**BELL BEND NUCLEAR POWER PLANT  
RESPONSE TO ENVIRONMENTAL  
INFORMATION NEEDS, FIRST SUBMITTAL  
BNP-2010-167                      Docket No. 52-039**

**Information Needs Items Responses  
Alternative Sites Audit  
June 15-17, 2010  
Bell Bend Nuclear Power Plant  
Luzerne County Pennsylvania**

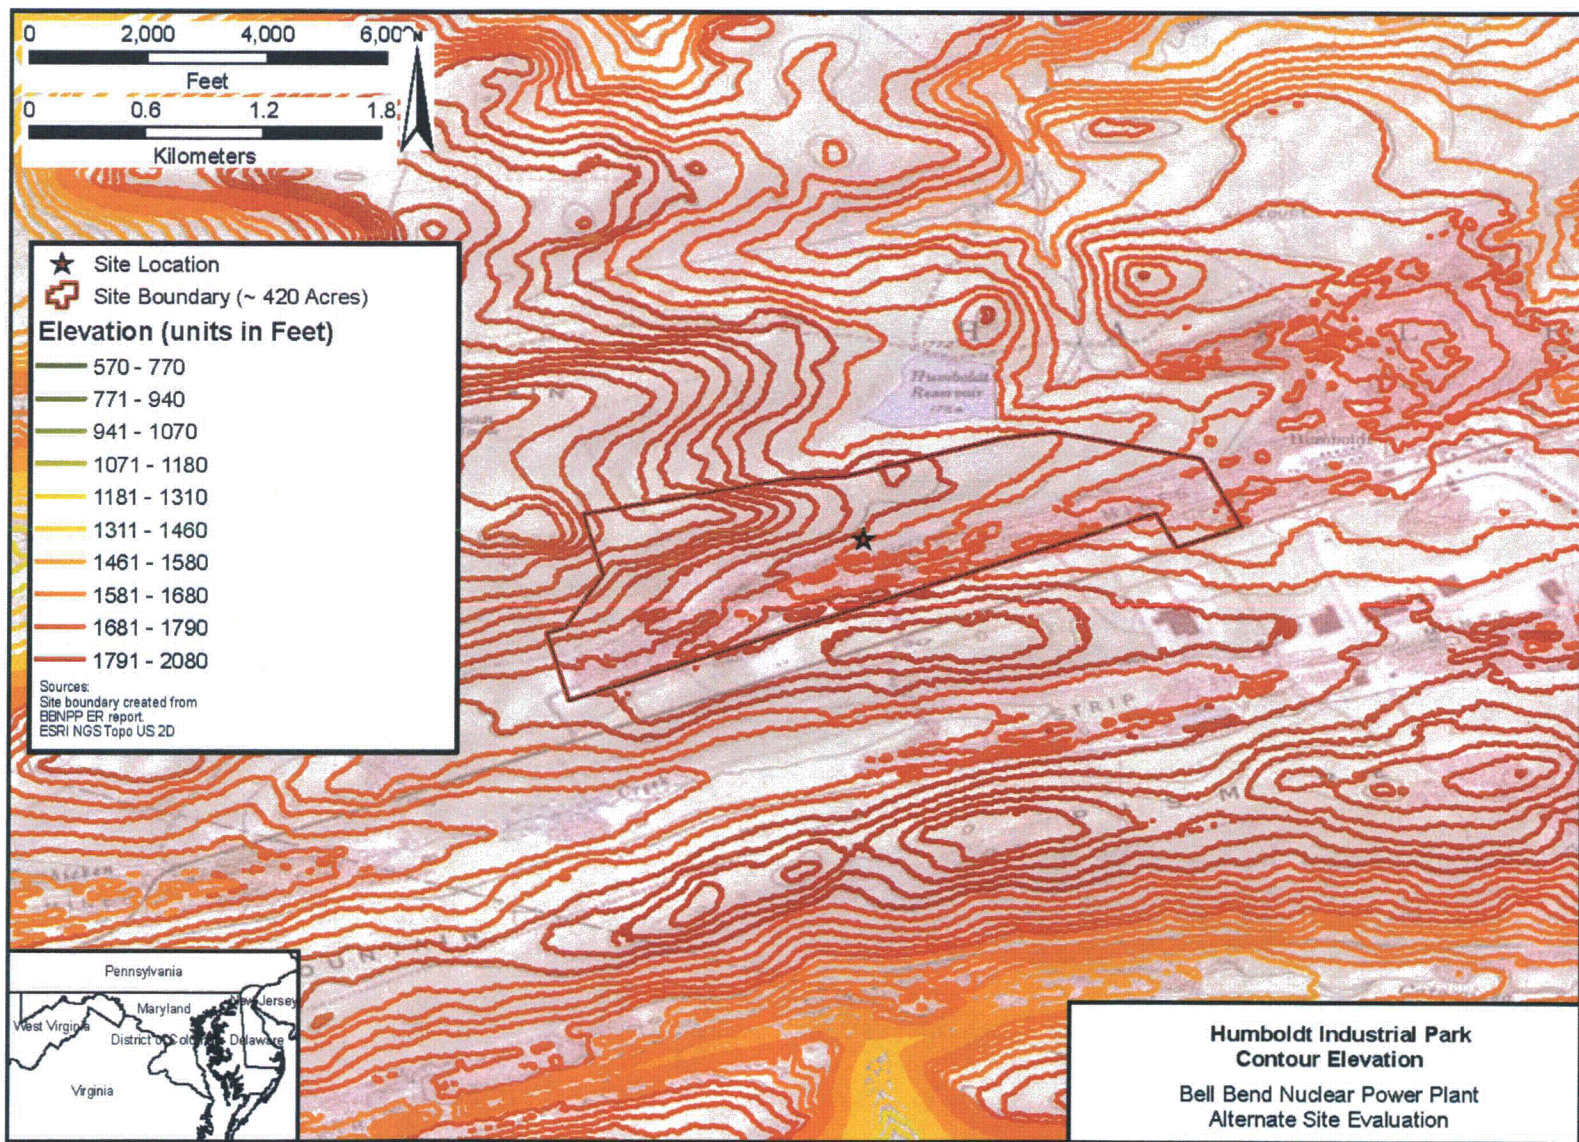
**Information Needs Text:** Provide an expert who can discuss Page C-1, Criterion 1e. Because Bell Bend, with greater than 130 ft of relief, scored 3.00 (page C-17) due to limited cut and fill (which is not included in the scoring rationale, p. A-1), please address the relative amount of cut and fill anticipated at Humboldt to warrant a score of 1.44 with a relief of >100 ft.

**Response:** A subject matter expert will be available to discuss Criterion 1e on page C-1 of the Bell Bend Nuclear Power Plant Alternative Site Evaluation Report (ASER). As noted by the NRC, "limited cut and fill" is not included in the scoring rationale for Criterion 1e. However, as provided in Appendix A of the ASER, Criterion 1e is a criterion that was subjectively scored by the Delphi panel. When the Delphi panel scored Criterion 1e, the panel felt that a limited amount of cut and fill should be a mitigating consideration for any site with greater than 100 feet of relief that did not have steep relief across the entire site. For example, although the Bell Bend site has 130 ft of relief across the site (see Appendix C of the ASER), the area within the approximately 420-acre site boundary where significant cut and fill will occur is limited. As stated in Appendix C and as shown in the attached figure of the topographic contour lines at the Humboldt site, the Humboldt site has approximately 230 ft (70 meters) of relief across the site with steep topography spanning the site and requiring a more significant amount of cut and fill. As a result, the Delphi panel subjectively scored Criterion 1e as 1.44 for the Humboldt site vs. 3.00 for the Bell Bend site.
